**ZEE Systems, Inc.**

***SERVICE LETTER 47-003-1***

2.0 PURPOSE: These motors have dual shafts. This letter provides instructions to make a one shaft motor from the dual shaft motor in the field. The evaporator has two blowers, the SZ47-003-2A Blower requires a motor that turns clockwise (CW) and the SZ47-003-1A motor requires a motor that turns counter-clockwise (CCW). Providing a motor with dual shafts, one side turning CW and the other turning CCW, allows spares to stock only one motor for either application. Rotation of the motor is determined by looking at the shaft to be used.

FIG. 1

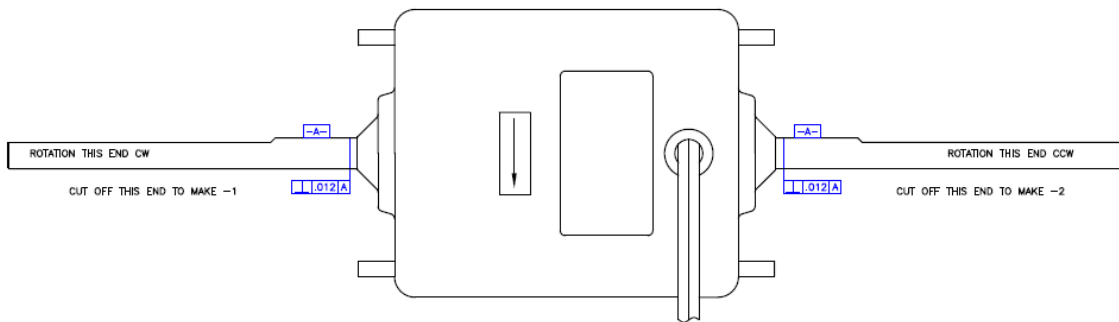
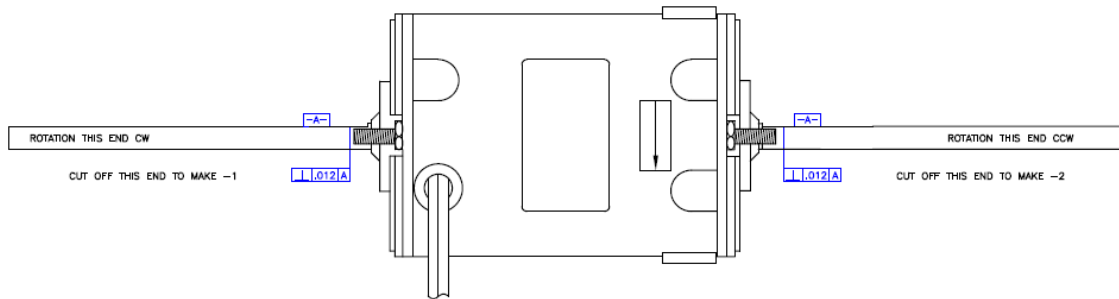
Cut off the opposite motor shaft as close to the housing as possible. Take precautions to insure that metal shavings do not contaminate the inside of the motor. See FIG. 1.

Motors with a clock-wise (CW) rotation mark **-2**.

Motors with CCW counter clock-wise (CCW) rotation mark **-1**.
